City of South Gate

SUBJECT: ADDENDUM NO. 1 - CITYWIDE TREE MAINTENANCE PROGRAM CITY PROJECT NO 690-ST

A1

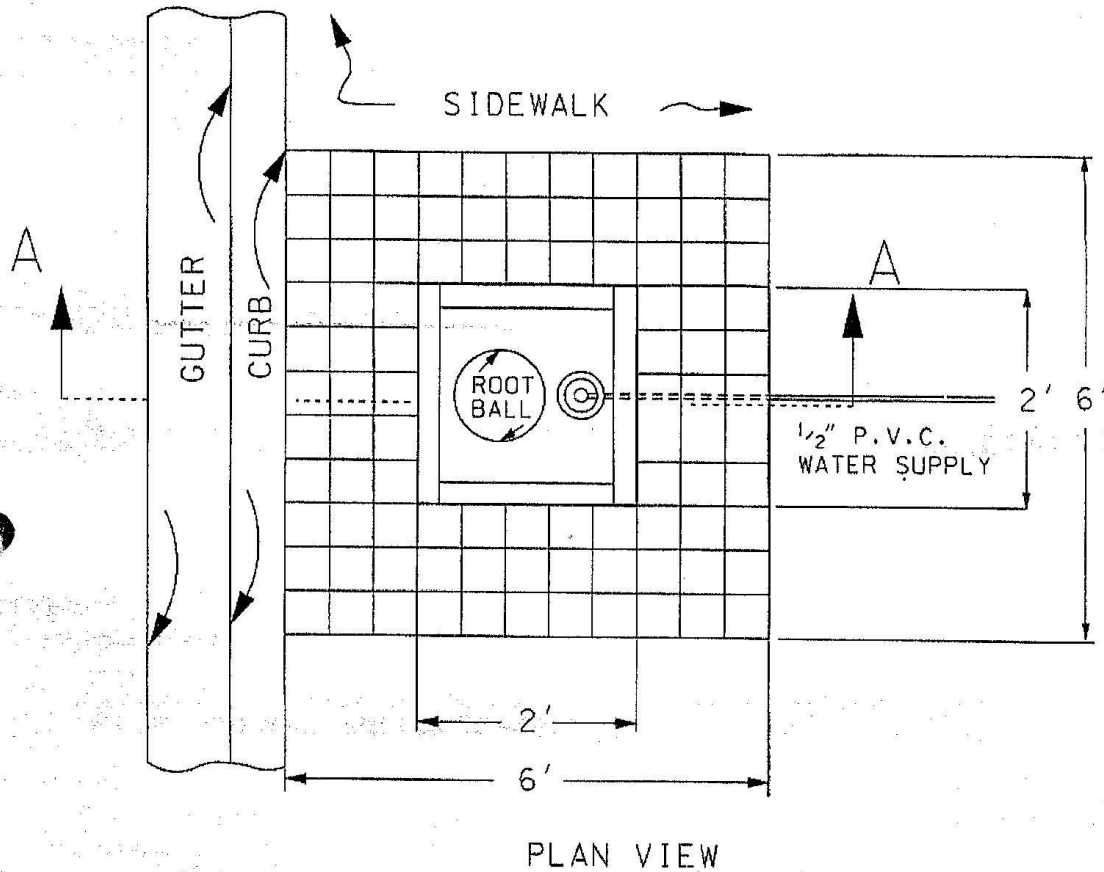
1. Referring to Bid item #17. What is an acceptable root irrigation device?
 - a. The Root barrier of choice is in the attached schematic. See attachment A1 and A2.
